Subject: AP1000 Response to Request for Additional Information (SRP 3)

AP1000 TECHNICAL REPORT REVIEW

RAI Response Number: RAI-SRP3.9.3-EMB2-07
Revision: 1

Figure 1: SG Design Basis Tube Thickness at each Evaluated Section

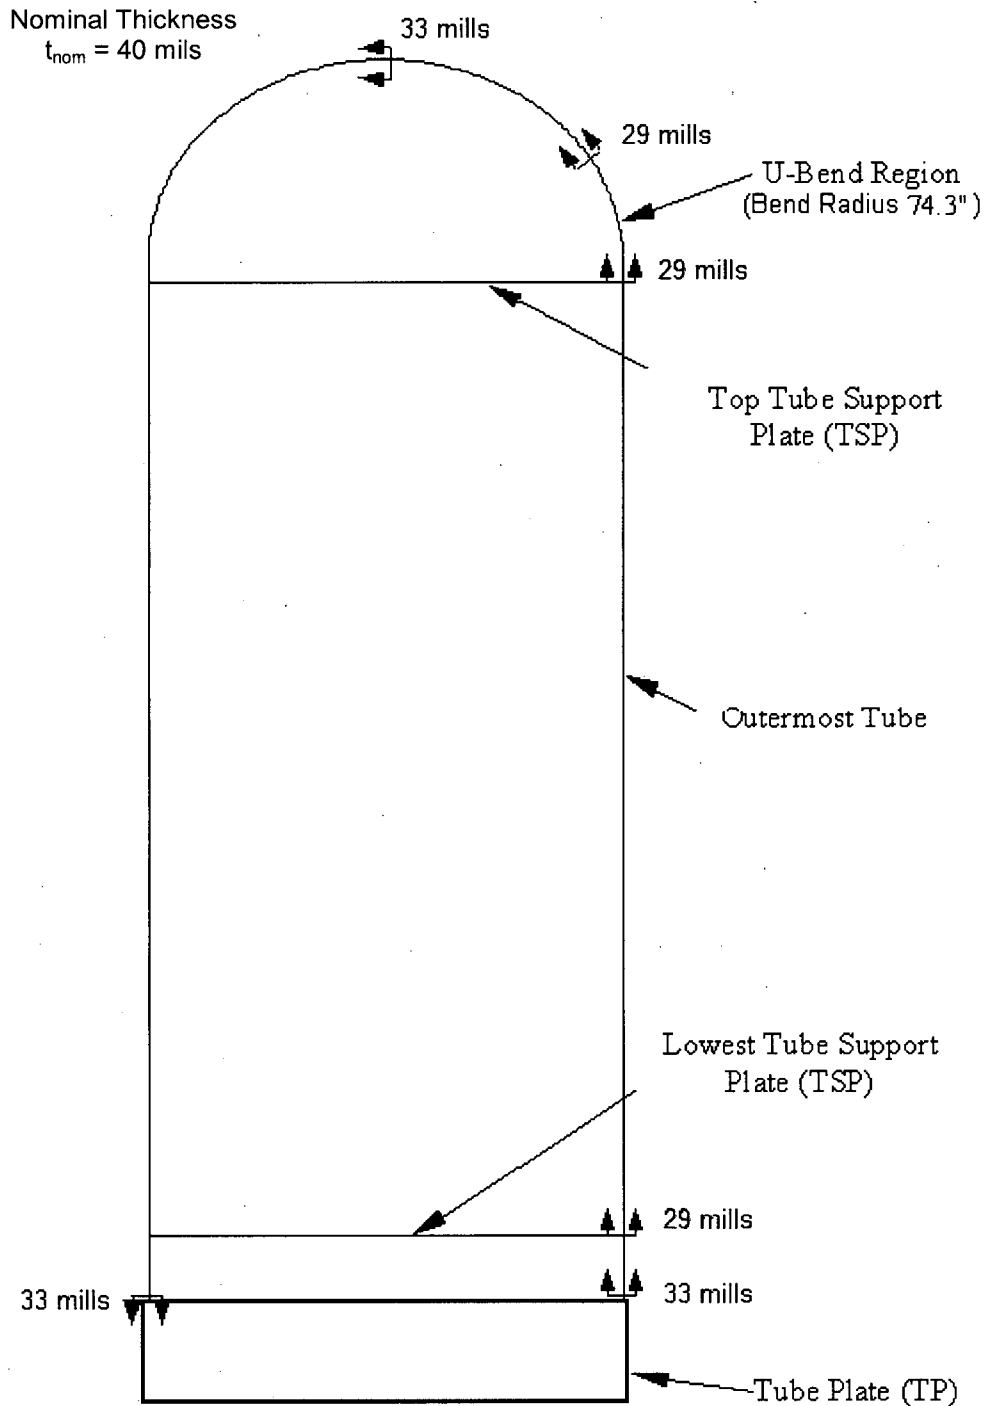
3. Clarify how the design basis tube wall thinning allowance is applied to individual tubes and what ASME Code criteria ensure the functional performance and integrity of the tubes.
4. Discuss the reasons for the conservatism when 3 mils allowance is used for loss of material due to corrosion/erosion in SG tubes. Include a discussion of the prototypicality of the experiments and the conservatisms in the interpretation of the results.
5. Discuss how the analyses performed provide an adequate wall thinning tube allowance due to flow induced vibration wear and the details for scaling measured workrate trends from "prototypic" test conditions.

3. The design basis tube wall thinning allowance is derived in the following manner from the nominal thickness of 40 mils. First the maximum specified diameter is used for the OD, which maximizes the end cap loads and bending stresses. From this value, the minimum specified tube thickness is subtracted from the outer radius r_o (1/2 OD) in order to calculate the maximum inner radius r_i . This assures that the hoop and axial stresses due to pressure are maximized. Erosion/corrosion is accounted for by subtracting 1 mil (secondary side erosion/corrosion allowance) from r_o and adding 2 mils (primary side erosion/corrosion allowance) to r_i . Further, in order to account for wear caused by Flow Induced Vibration (FIV), the maximum calculated wear of 4 mils is subtracted from the outer radius r_o at the applicable sections of the tube. Once the erosion/corrosion and the wear due to FIV are accounted for, the minimum thicknesses are calculated. From this, the tubes are evaluated at 27.5 % degradation with FIV wear and at 17.5% degradation without FIV wear. Figure 1 shows the design basis tube thickness at each evaluated section in the tube.

Each tube section is evaluated to the dimension described above and shown to pass Section III of the ASME Code for Service Levels A, B, C and D along with test Conditions for Primary stresses and Primary plus Secondary stresses. ASME external pressure requirements are also evaluated with the dimensions described above and are shown to pass assuming the use of Code Case N-759-1.
